## 波形配置验证说明

针对 AIOS 在按照图 1 所示波形参数进行波形配置后出现的问题：

图 3 修改后波形验证示意图

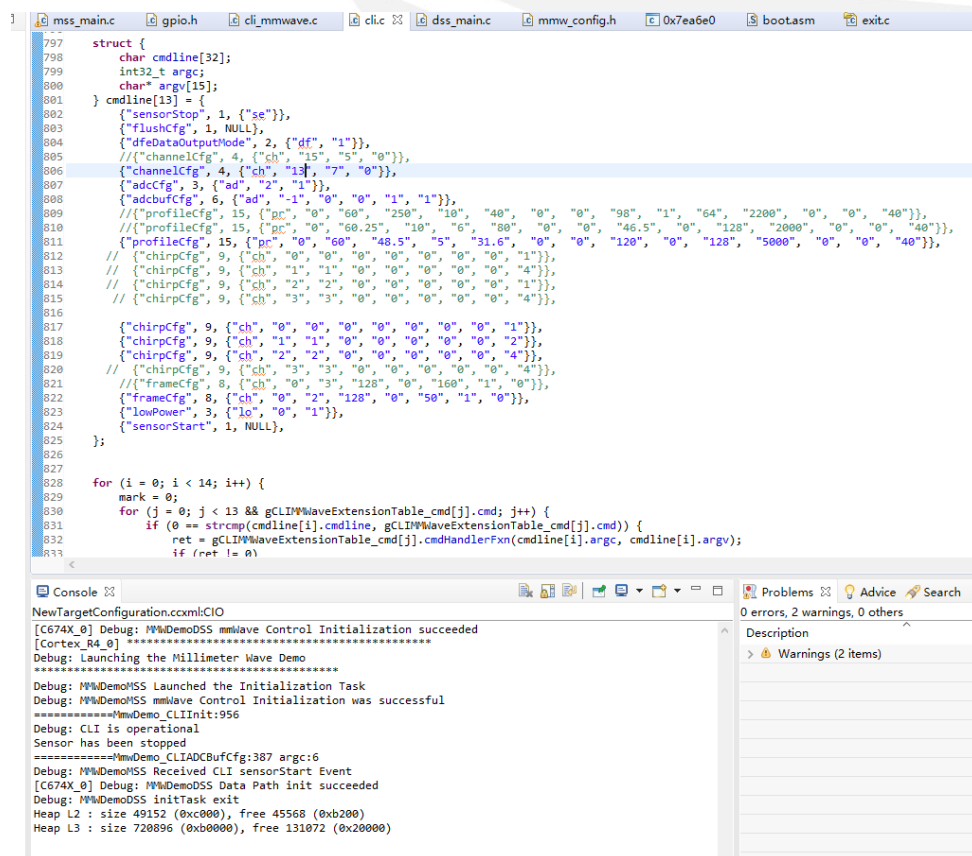
将修改后的波形参数放到 AIOS 第二次提供工程中, 调试结果如下图所示, 问题 1 和问题 2 得到解决。
